Cadia East Gold/Copper Project

*Modification Assessment
(MP 06_0295 MOD 12)*

September 2018

Figure 2: Proposed Modification Layout

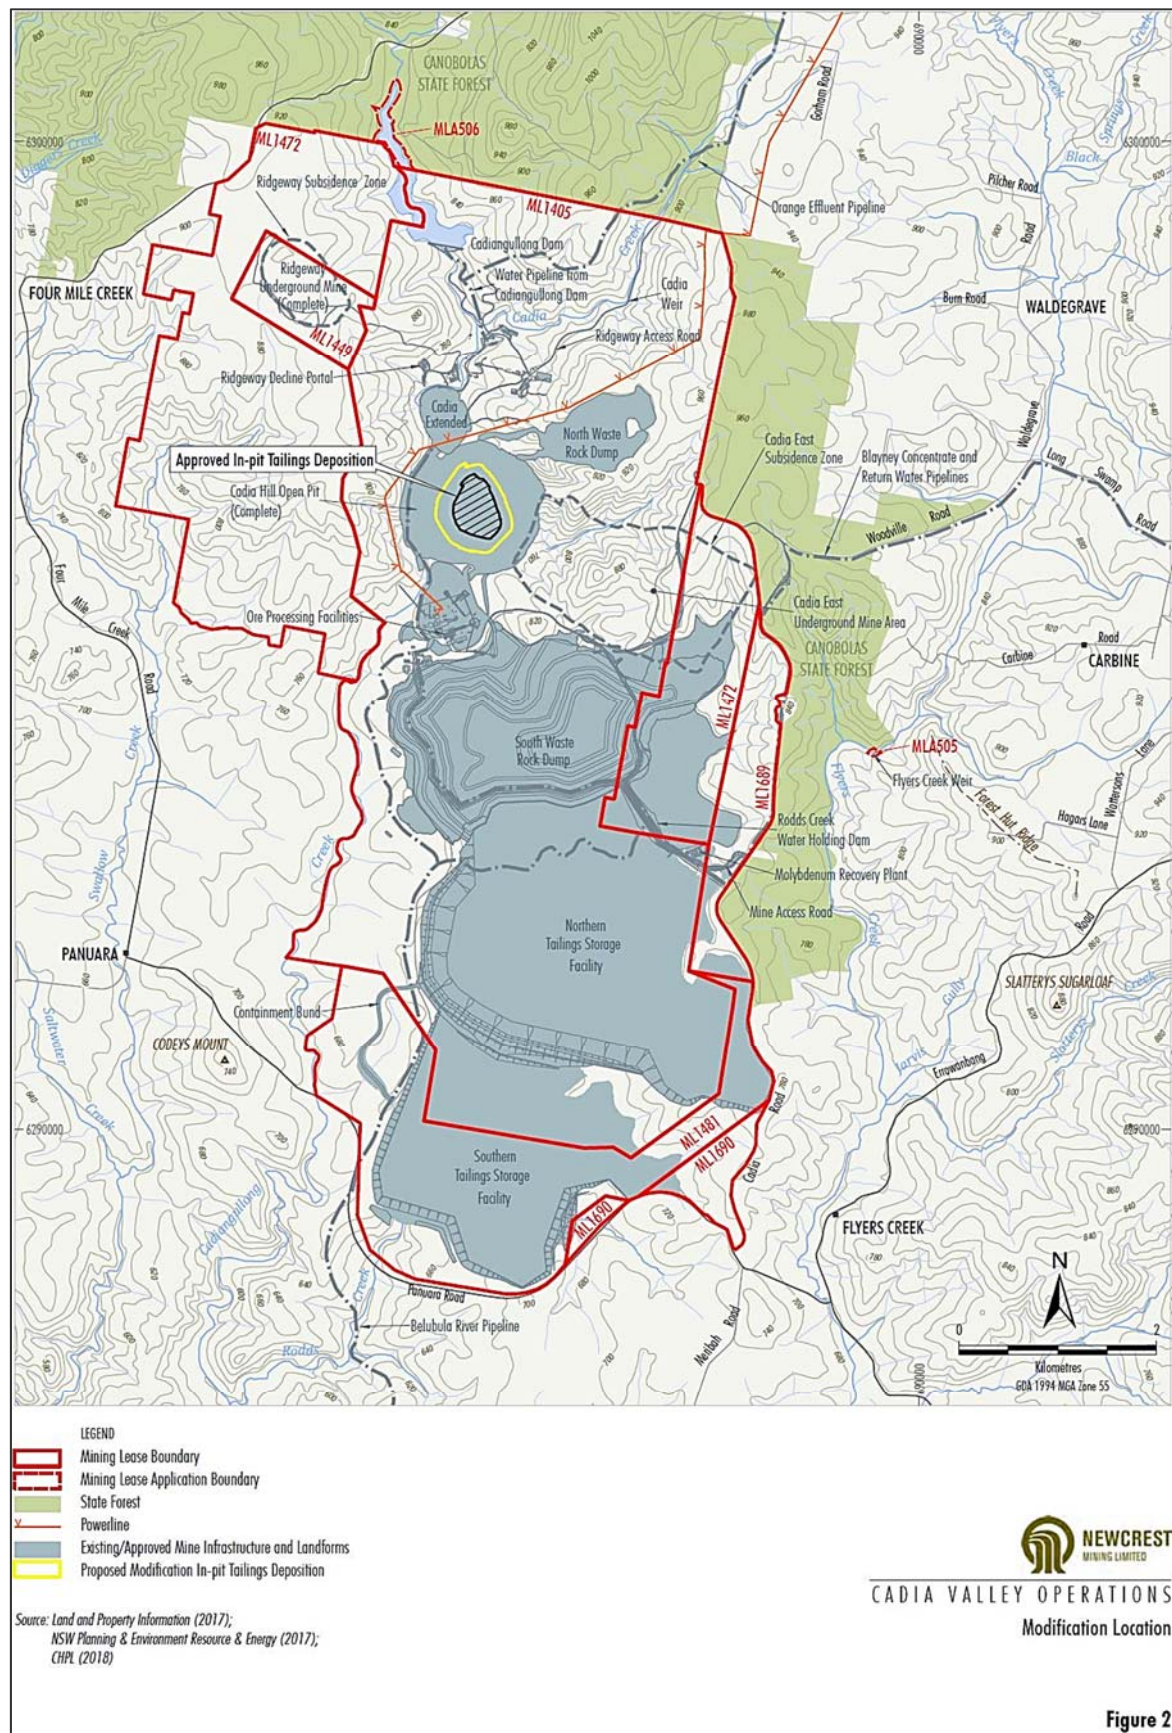
The approved and proposed deposition areas are shown in **Figure 2**. The proposed modification activities are all within previously disturbed areas.

The Cadia Hill open cut pit is around 500 metres (m) deep (Australian Height Datum (AHD) 220 m). The proposed modification would increase the tailings depth by 140 m, up to a final elevation of AHD 560 m compared to the currently approved level of AHD 420 m, once consolidated.

Figure 3: Groundwater levels during operations and post mining recovery

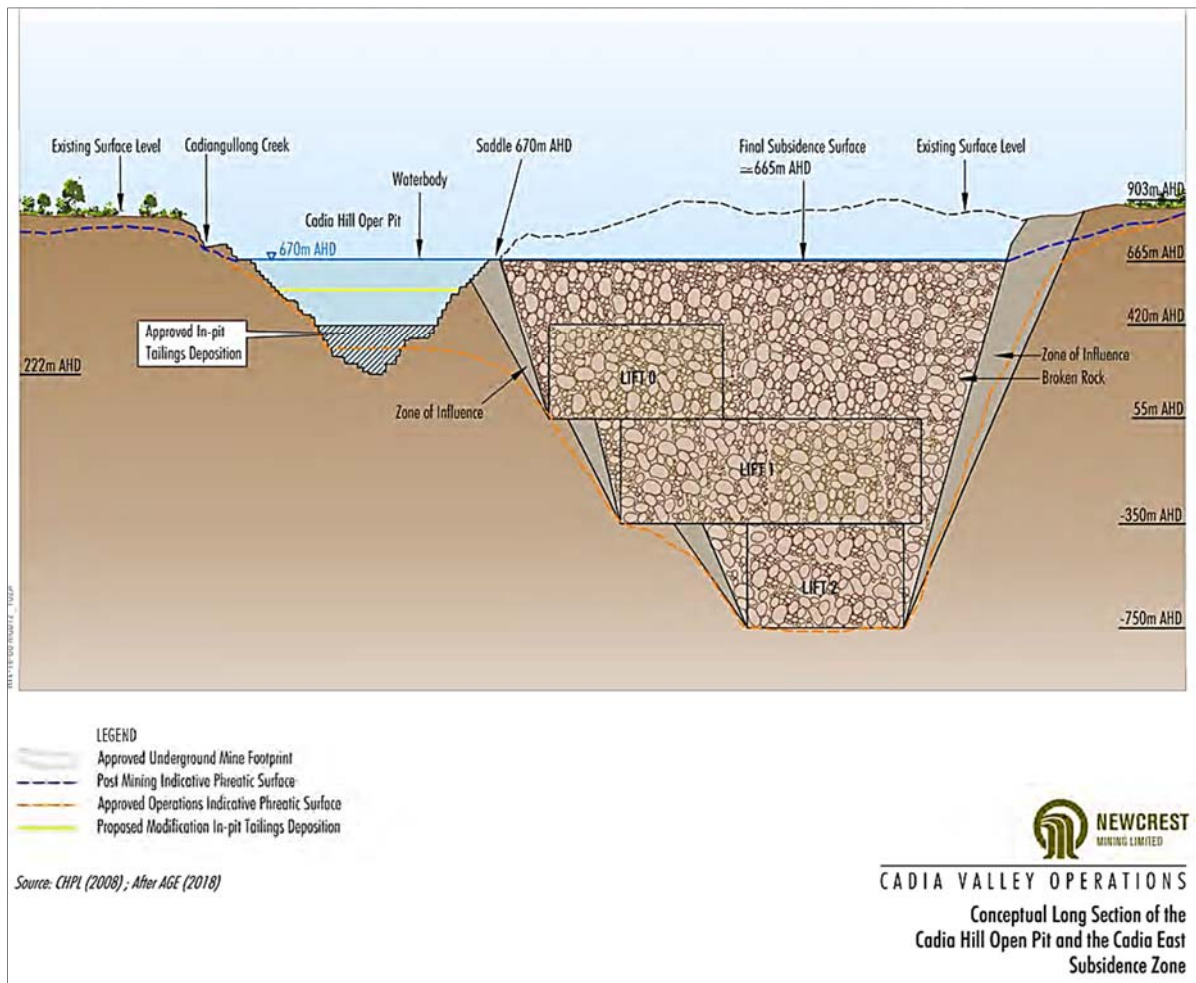
This occurs because groundwater from the surrounding rock flows into the open cut, the underground mining panels, and the voids/fractures formed from subsidence of the land over the cave mining area. Once mining is completed, groundwater levels are predicted to recover until a new equilibrium is reached and a pit lake would form, with a direct hydraulic connection between the open cut pit and subsidence void (see **Figure 3**).

The predicted equilibrium level of 670 m AHD for the pit/subsidence lake would also be 51 m below the spill point at 721 AHD into the adjoining surface water system, with the base level of Cadiangullong Creek at 708 m near the pit and 38 m above the pit lake equilibrium level.

This very low permeability is supported by the low groundwater inflow observed seeping into the pit and the high pore water pressure measured close to the pit wall. This is shown in **Figure 3** above where the groundwater or phreatic surface during mining operations is maintained near the void wall. It is estimated from groundwater modelling that there is currently around 0.7 megalitres (ML) of seepage into the pit daily.
